**Pacific Gas and
Electric Company®**

PG&E Letter DCL-06-075

Response to NRC Request for Additional Information Regarding ASME
Section XI Inservice Inspection Program Relief Request NDE-SLH

**PG&E Response to NRC Request for Additional Information (RAI)
Regarding ASME Section XI Inservice Inspection Program Relief
Request NDE-SLH**

Diagram of DCCP Unit 1 Reactor Vessel Showing the Location of the Lower Shell to Lower Head Circumferential Weld (Weld No. 10-442) and Also the Location of the 6 Core Support Lugs
 Figure 1

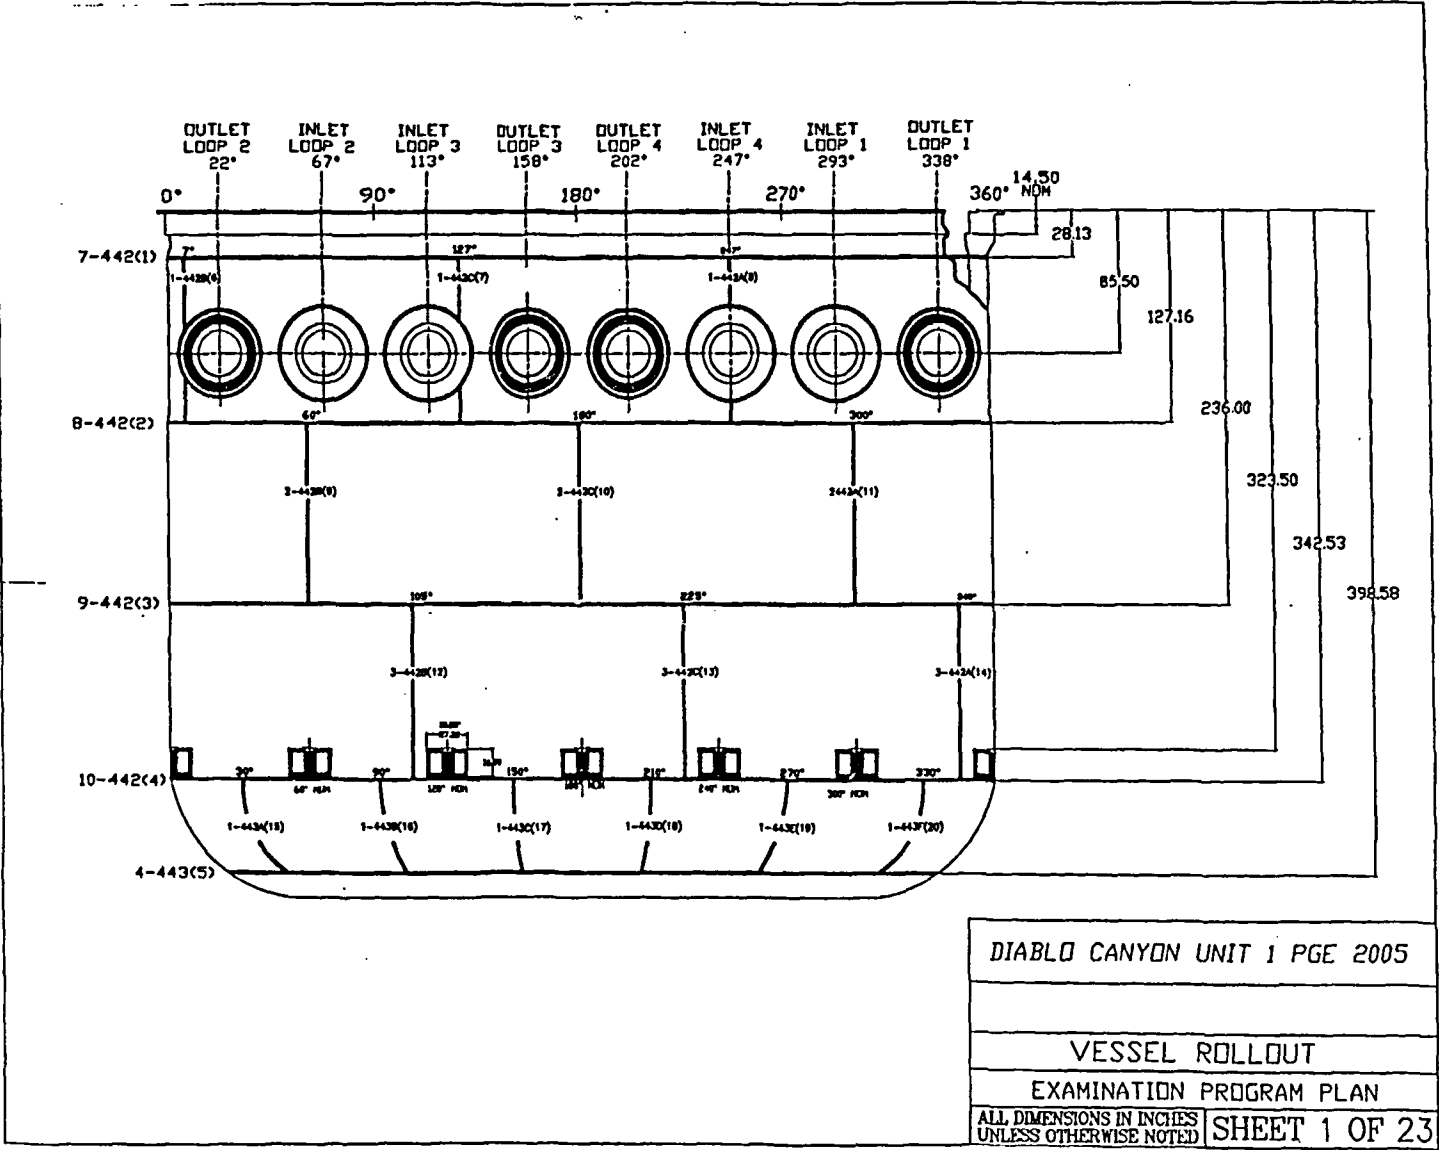
Provide more detail (including drawings) regarding the [NDE] examination. For example, transducers used, direction of scans, and was the ultrasonic examination of the reactor pressure vessel circumferential shell weld [to the bottom] conducted in accordance with techniques qualified by demonstration for Appendix VIII supplements 4 and 6 of the 1995-96 Addenda of ASME Section XI. A good example for this type of relief is VEPCO's letter dated December 12, 2005 for Surry Power Station Unit 2 Relief Request PRT-02, TAC no. MC9224.

The inspection of Diablo Canyon Power Plant (DCPP) Unit 1 reactor vessel lower shell to lower head circumferential weld (Weld No. 10-442) during Unit 1 Refueling Outage 13 (1R13) was conducted using a procedure and techniques qualified by demonstration for 1995 edition/1996 Addenda ASME Section XI Appendix VIII examinations in accordance with Supplements 4 and 6. The examination used a combination of 45 degree angle search units with shear and longitudinal wave propagation and 30 mm or greater focal depths. The sound beams from these transducers were directed in four orthogonal directions parallel and perpendicular to the weld in as close proximity to the six core support lugs as the inspection device and transducer sled would allow. Figures 1, 2, and 3 depict the location of this weld in the reactor vessel, the scanning limitations for parallel and perpendicular scans below the core support lugs, and in between the lugs respectively.

The physical size of the transducer sled limited the approach to the core support lugs without hazarding the assembly and causing damage and loose parts concerns. Calculation of the weld and volume coverage afforded by each set of transducers by the data analysts resulted in a combined coverage of 75.36 percent. Table 1 provides a breakdown of percent coverage of the required examination volume by scan direction and transducers. This coverage is within one percent of the coverage as detailed in the Surry Power Station Unit 2 Relief Request PRT-02. The Surry Power Station Unit 2 reactor vessel has four core support lugs, as opposed to the DCPP Unit 1 reactor vessel, which has six lugs.
